Access Compliance Report

Intersection ID: 16626	Main Street: INDEPENDENCE_WOODS_DR	Cross Street: HOOPER_CT	Location: SE
ADA ID: BAE6960A6340	Ramp Type: PerpDiag	Initial Pass/Fail: Fail	Overall Compliance: No
Severity Score: 33.75			
Codes/Mitigation Info/Possible Solution		Field Measurements/Component Compliance

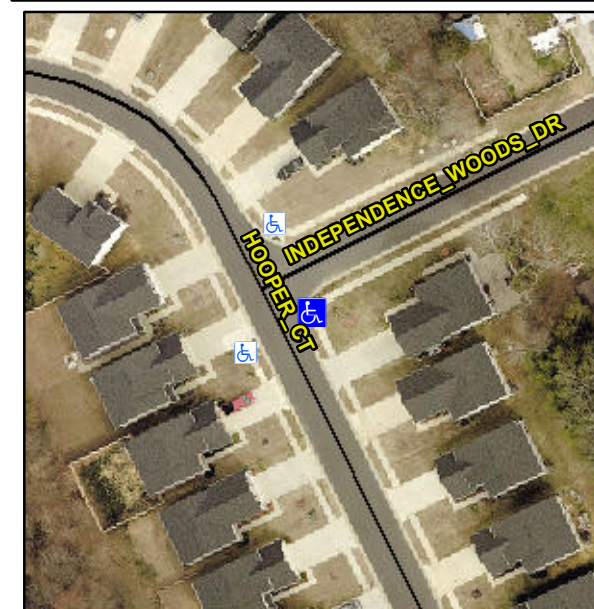
R304.5.1, R304.2.2

Compliance	Description	Data	Compliance	Description	Data
N/A	Ramp Length (in)	48.0	No	Ramp Slope (%)	12.6
No	Ramp Width (in)	46.5	Yes	Ramp XSlope (%)	1.7
N/A	Flare Type LT	N/A	N/A	Flare Type RT	N/A
N/A	Flare Slope LT (%)	N/A	N/A	Flare Slope RT (%)	N/A
N/A	Flare Traversable LT?	N/A	N/A	Flare Traversable RT?	N/A
N/A	Landing Length (in)	N/A	N/A	DWS Provided?	N/A
N/A	Landing Width (in)	N/A	N/A	DWS Contrast?	N/A
N/A	Landing Slope (%)	N/A	N/A	DWS Length (in)	N/A
N/A	Landing X Slope (%)	N/A	N/A	DWS Full Width?	N/A
N/A	Landing Curb? (Y/N)	N/A	N/A	DWS Offset (in)	N/A
N/A	Shared Landing?	N/A			
N/A	Gutter Ponding?	N/A	N/A	Gutter Slope (%)	N/A
N/A	Gutter Lip Ht (in)	N/A	N/A	Gutter X Slope (%)	N/A
N/A	Painted X Walk1?	No	N/A	Painted X Walk2?	No
	X Walk 1 Direction	To N		X Walk 2 Direction	To W
N/A	X Walk 1 Width (in)	N/A	N/A	X Walk 2 Width (in)	N/A
	X Walk 1 Slope (%)	1.7		X Walk 2 Slope (%)	1.5
	X Walk 1 X Slope (%)	1.4		X Walk 2 X Slope (%)	1.1

Remove & Replace Curb Ramp With Two New Directional Ramps or Equivalent.
